COMPLETENESS REVIEW COMMENT RESPONSE

PROJECT NAME
COZY RESIDENTIAL

CASE NO.
23-101981-PLN

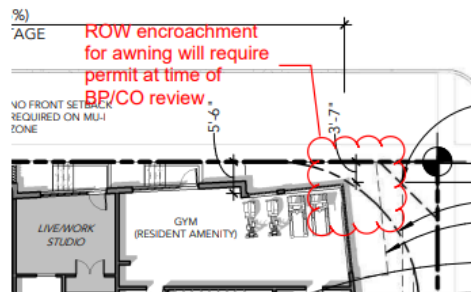
- *A preliminary review of the applicants plans shows that proposed storm pipe slopes don't meet minimum velocity requirements. This might indicate challenges making the storm design work due to the pond's location on highest part of site, farthest away from public storm connections.*

RESPONSE: Please refer to revised drawings, specifically the Grading & Drainage Plan, Sheet C2.0, which provides details that supports the drainage and stormwater design.

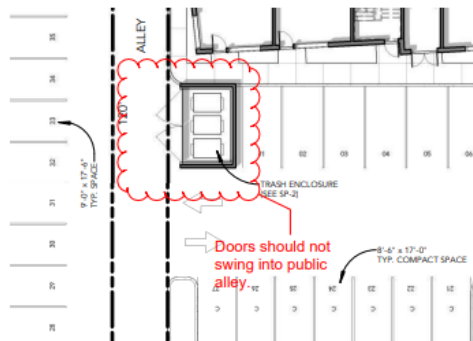
A. Row encroachment for awning will require permit at time of BP/CO review.

RESPONSE: Encroachment permits for building awnings/canopies will be obtained as required, historically this would happen during the building permit process.

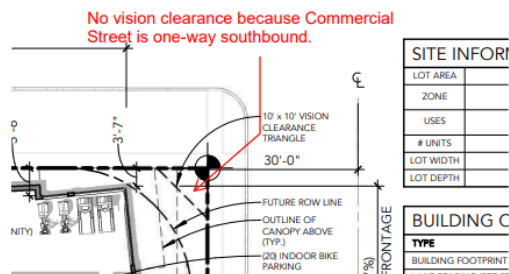
B. Doors should not swing into public alley.

RESPONSE: The trash enclosure has been shifted further from the property line to allow door swing to occur within the development site. Please refer to revised plans for compliance.

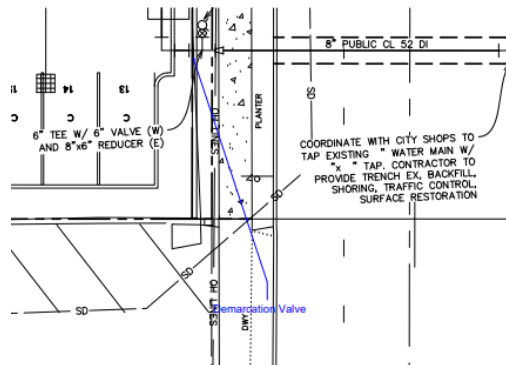
C. No vision clearance because Commercial Street is one-way southbound.

RESPONSE: Thank you for confirming.

3. C3.0 Utility Plan

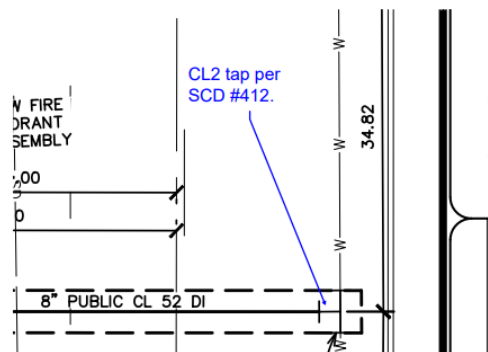
C. Demarcation Valve

RESPONSE: The submitted civil plans are preliminary and not meant as construction documents. Construction documents will be prepared and submitted for review and approval as required.

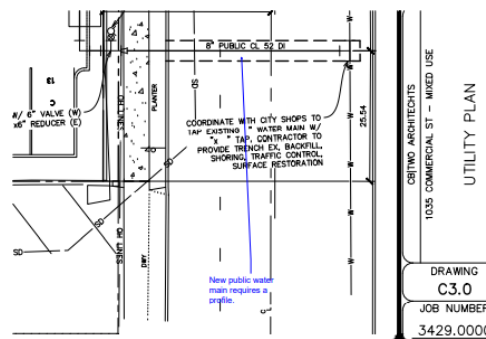
D. CL2 tap per SCD #412.

RESPONSE: The submitted civil plans are preliminary and not meant as construction documents. Construction documents will be prepared and submitted for review and approval as required.

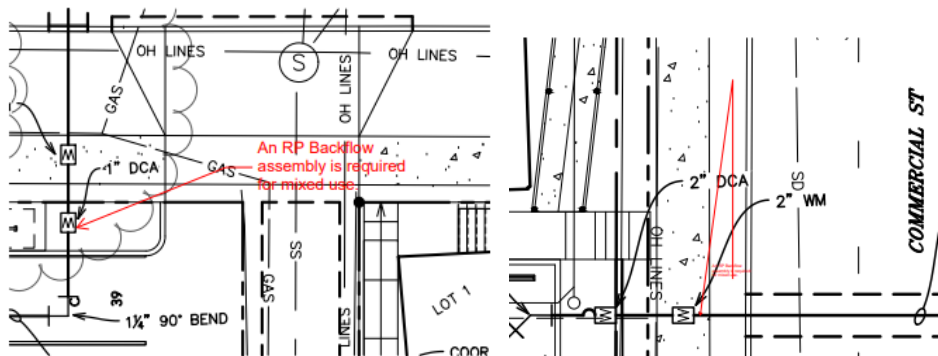
E. New public water main requires a profile.

RESPONSE: The submitted civil plans are preliminary and not meant as construction documents. Construction documents will be prepared and submitted for review and approval as required.

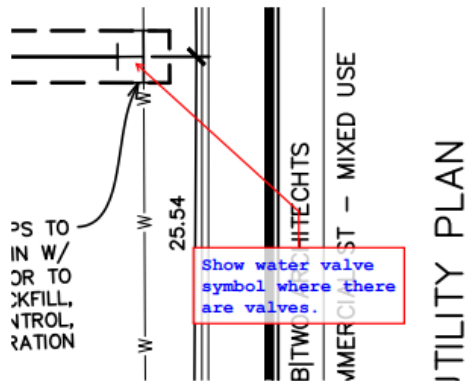
F. An RP Backflow assembly is required for mixed use.

RESPONSE: A backflow assembly will be provided. As noted previously, these plans are preliminary, construction documents will be prepared providing

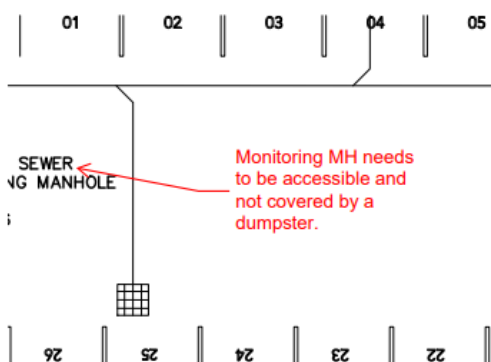
G. Show water valve symbol where there are valves.

RESPONSE: Detailed information will be provided in the construction plans that will be provided for building permit submittal.

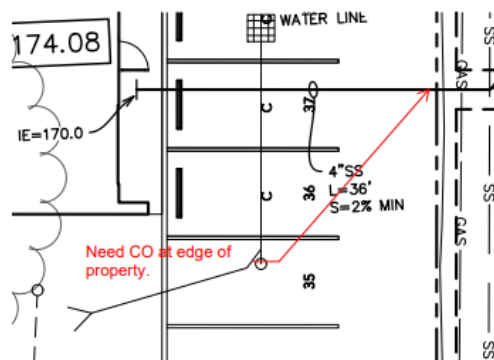
G. Monitoring MH needs to be accessible and not covered by a dumpster.

As-builts indicate this
is a 8" SS

H. As-builts indicate this is a 8" SS.

RESPONSE: The trash enclosure has been shifted to allow the monitoring manhole to be outside of the dumpster for better access. Please refer to the revised Utility Plan for confirmation.

RESPONSE: Noted and addressed.

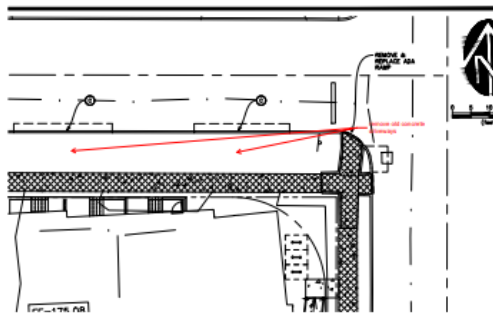
I. Need CO at edge of property.

RESPONSE: Noted.

4. C4.0 Surfacing Plans

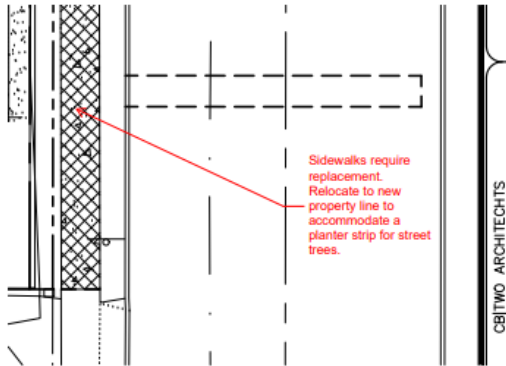
A. Remove old concrete driveways.

RESPONSE: Existing driveways providing access from Bush Street to the development site will be removed and new Type "C" curbs will be installed to match existing curbs along the Bush Street frontage.

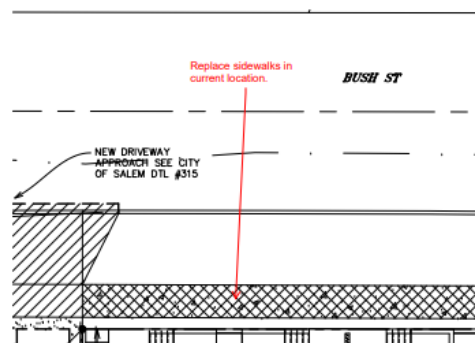
B. Sidewalks require replacement. Relocate to new property line to accommodate a planter strip for street trees.

C. Street trees required.

RESPONSE: Sidewalks will be replaced. The sidewalk on Commercial is shown in its existing location to meet sidewalks located in front of adjacent properties and those across Bush Street.

RESPONSE: Street trees will be provided either in the ROW or adjacent to it.

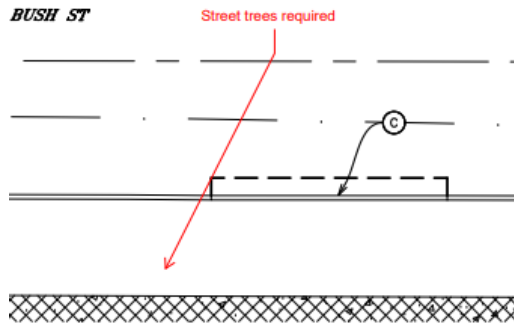
D. Replace sidewalks in current location.

RESPONSE: Replacement of sidewalks along Bush Street are proposed. The new sidewalk will be constructed in the same location as existing.

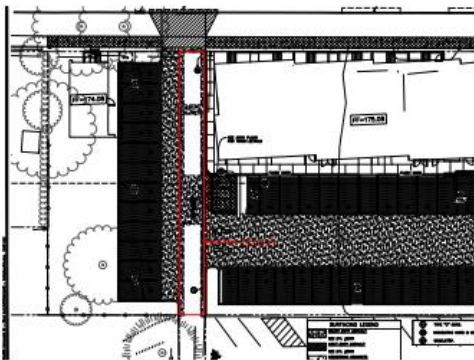
E. Street trees required.

RESPONSE: Street trees will be provided as required. The conceptual Landscape Plan, Sheet SP-3 indicates street trees along Bush Street where no trees are currently located.

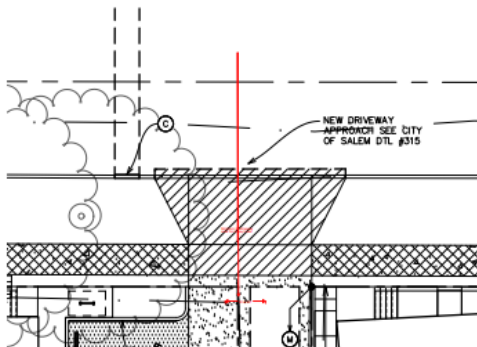
F. Repave entire alley within development.

G. Minimum 22 driveway aisle' for 2-way travel.

RESPONSE: Currently we are proposing to grind and inlay with a 3-inch overlay of asphalt. Please see revised Surfacing Plan, Sheet C4.0, for details.

RESPONSE: The driveway aisle will be 22-feet wide allowing 2-way traffic as required. Please refer to the revised plans for dimensional information.
